Preliminary Consultation
MONTGOMERY COUNTY HISTORIC PRESERVATION COMMISSION
STAFF REPORT

Address:	7203 Cedar Ave., Takoma Park	Meeting Date:	8/17/2022
Resource:	Contributing Resource Takoma Park Historic District	Report Date:	8/10/2022
Applicant:	Mark Foster	Public Notice:	8/3/2022
Review:	Preliminary Consultation	Staff:	Dan Bruechert
Proposal:	Front Stoop, Fenestration Alteration, and Dormer Alteration

Work Item 1: Front porch steps, con't

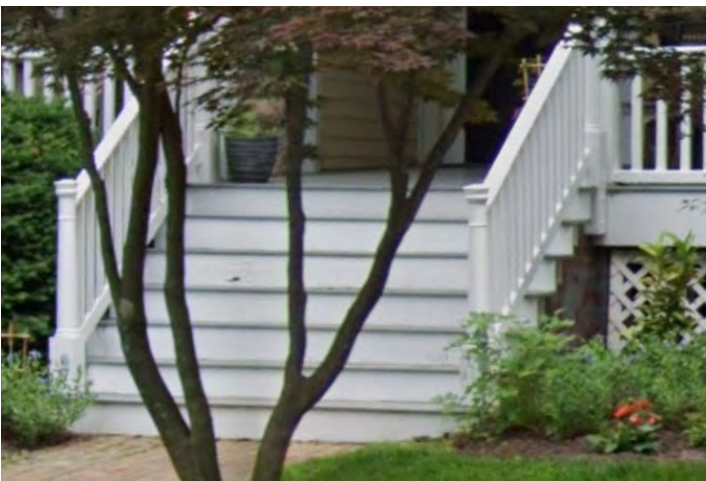
The application states that the existing concrete front stairs have settled to the left and do not satisfy existing code requirements. The proposal will construct new composite stairs over the existing and support the new treads with wood blocking. The submitted materials do not specify what composite material is proposed.

Based on Staff's observations from the site visit, it appears that this work has already been completed. Staff will conduct a more thorough investigation before the Preliminary Consultation hearing, however, the HPC generally finds that composite materials are inappropriate for front stairs and decks on Contributing and Outstanding resources in the Takoma Park Historic District, because they are too shiny to be a compatible substitute for wood and do not develop a patina over time. Staff finds that either wood or masonry would be an appropriate material for replacement front porch stairs at the subject property and would recommend the HPC approve a HAWP for either of those materials and require that the existing, unpermitted work be removed.

Work Item 2: Restored side stoop roof

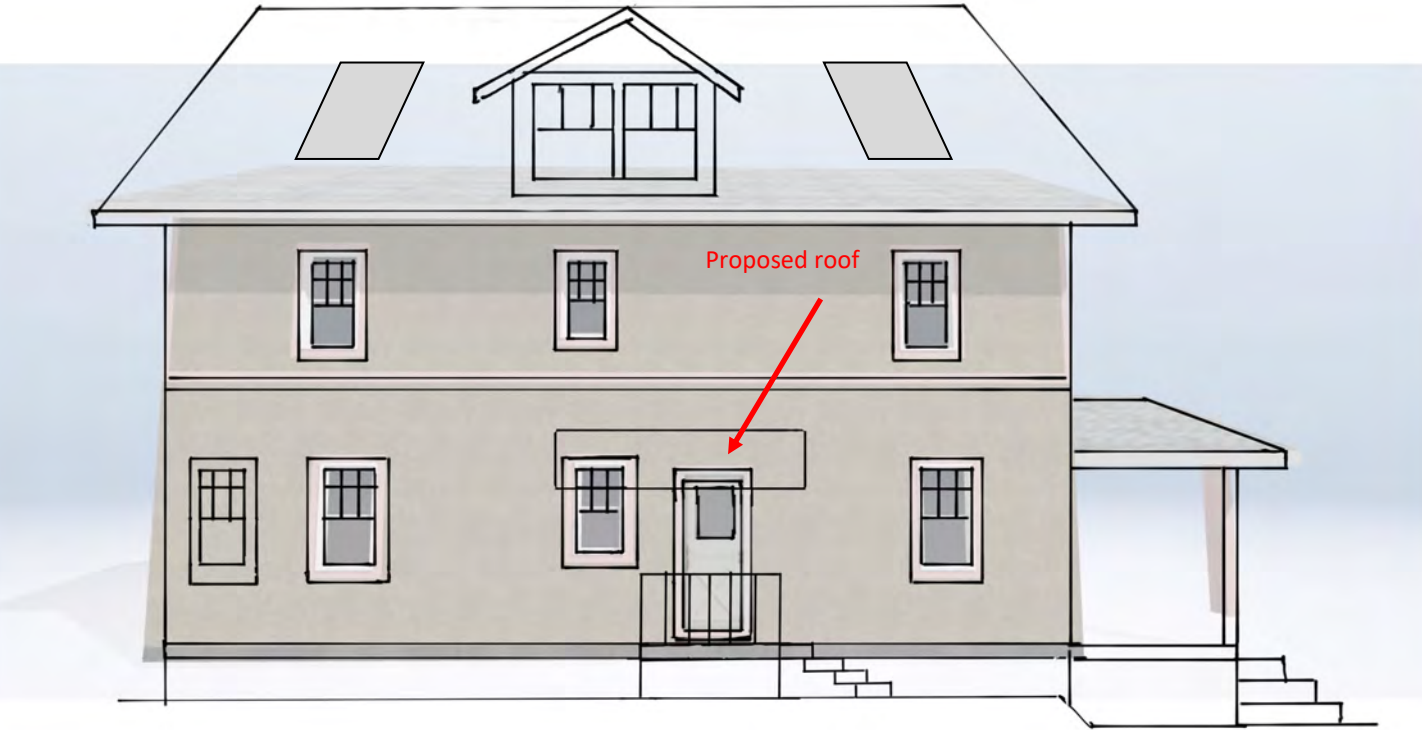
Above the left side door is a ghost of a previously installed roof. The applicant states that rain can enter directly into the basement and proposes installing a roof over the door to shed rain away from the house. The design submitted is illustrative without enough details to provide thorough feedback. However, Staff recognizes that there is physical evidence of a roof in this location, so a roof would be acceptable. Staff finds that either a shed or simple gable roof would be appropriate and requests feedback from the HPC on the preferred roof form over this entrance and material specifications for the new alteration.

Existing sash dimensions

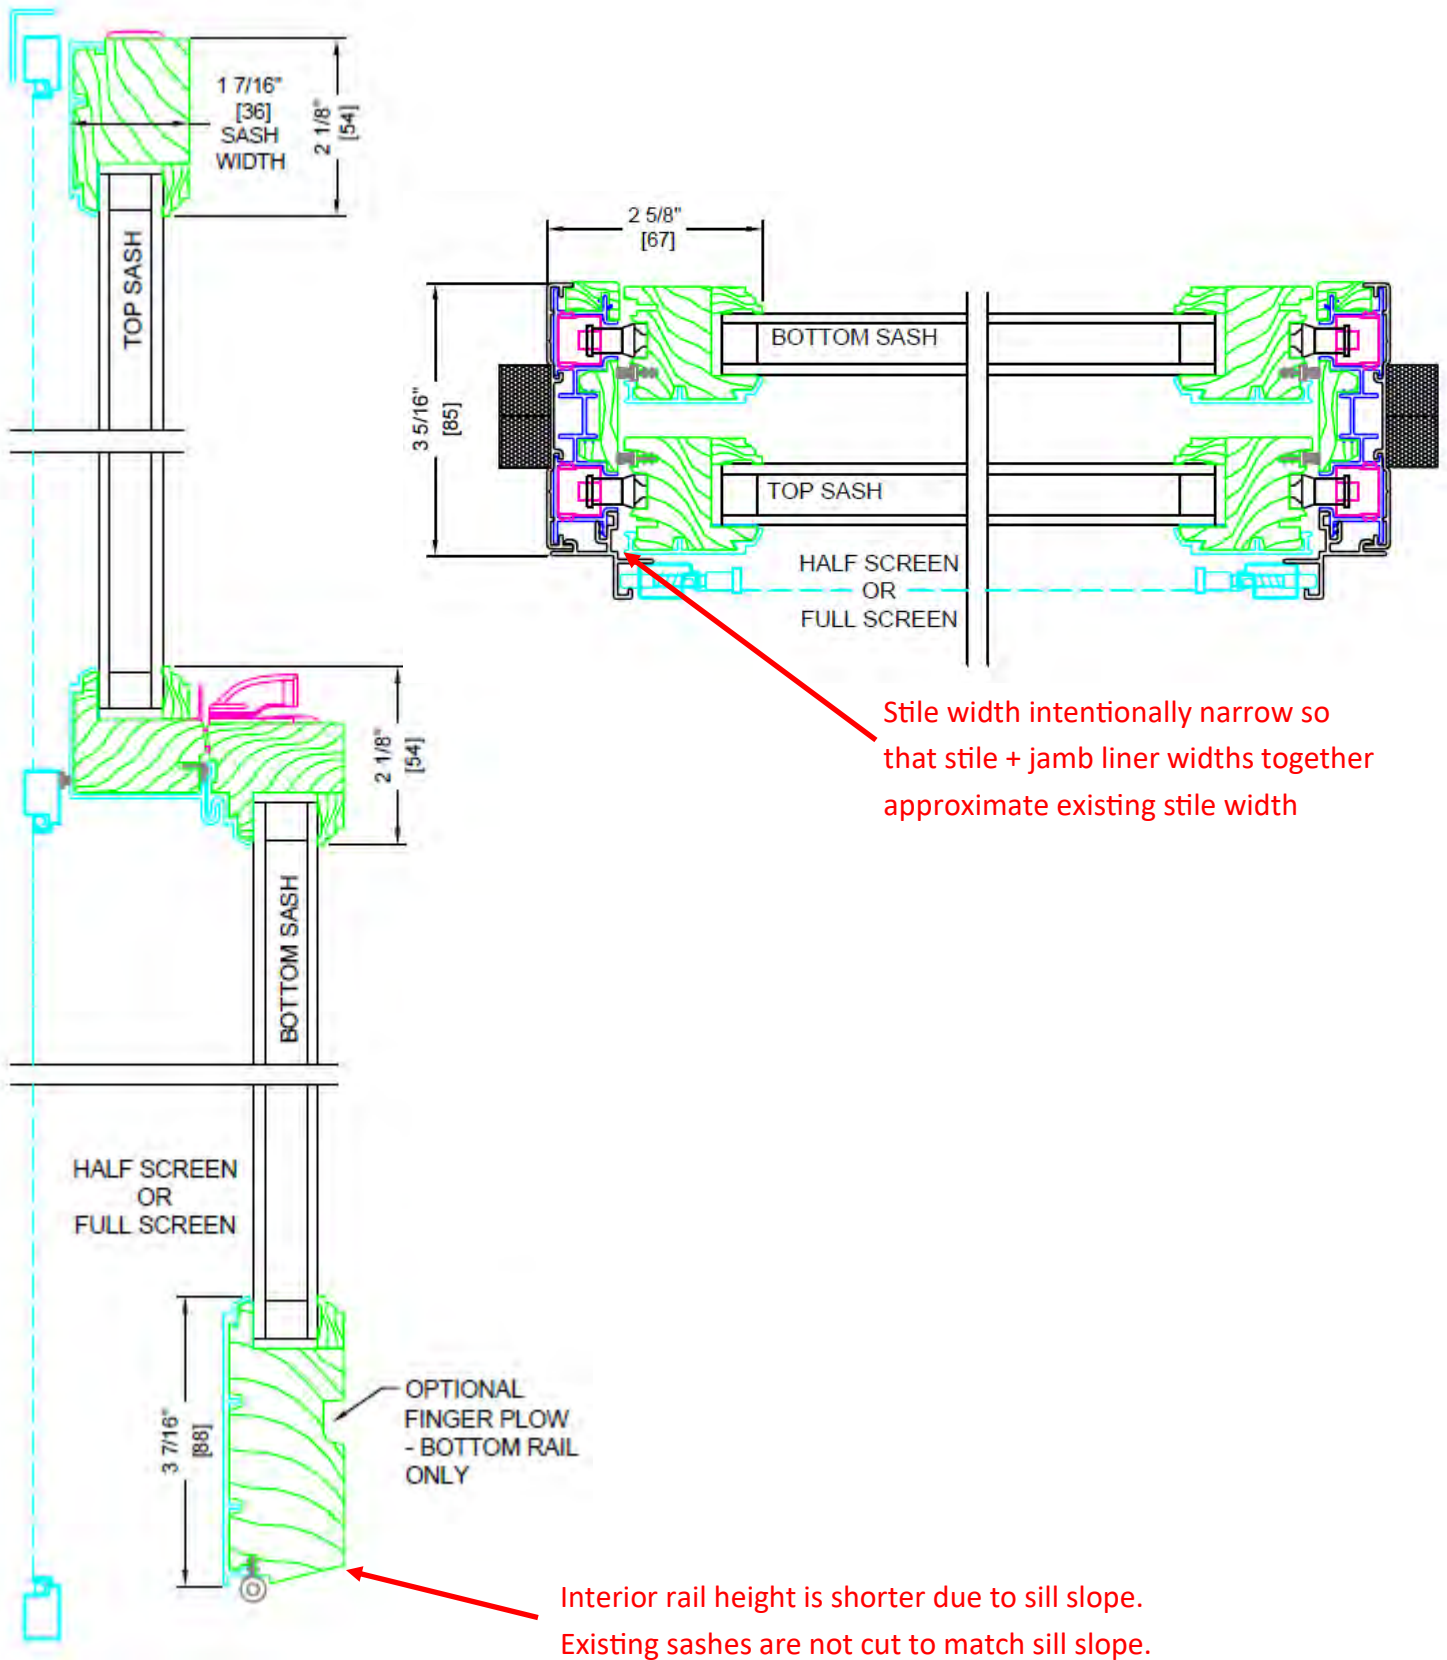
Staff has several concerns with the proposed window treatment. First, applicants are generally required to demonstrate that the windows have degraded beyond repair before the HPC would consider approving the removal of the historic windows. Staff does not find the applicant has satisfied that burden and more information needs to be included with a HAWP application. Second, traditionally constructed wood windows can be repaired, which leads to improved performance while maintaining the historic appearance. The county also offers a tax credit for the repair of historic exterior fabric, including windows, for 25% of the qualified expenses, which can help make the cost of window repair equal to replacing the historic sashes. The County tax credit can be used in combination with the Maryland

Rehabilitation Tax Credit of an additional 20%. Third, Staff's experience with sash packs has not been entirely positive. Sash packs retain the historic window frame and install new jamb liners. Depending on the specifications, the sash packs can reduce the size of the glazing, making the overall window assemblies look chunkier than the historic configuration. Additionally, some of the jamb liners have exposed vinyl surfaces that are frequently bright white and, because they are vinyl, do not weather and darken over time and draw visual attention. If the HPC determines that the windows can be replaced, then detailed specifications for the proposed sashes including complete measurements and profiles of an existing window need to be submitted for review along with the final HAWP submission.

Preservation of the one-over-one original wood windows meets each level of preservation guidance for the district. If replacement windows are considered, they should match the existing one-over-one configuration. Other configurations were present on houses of this style and age; however, they are conjectural and not specific to the known condition of this house. Staff requests HPC feedback on the preferred window specifications including the configuration.
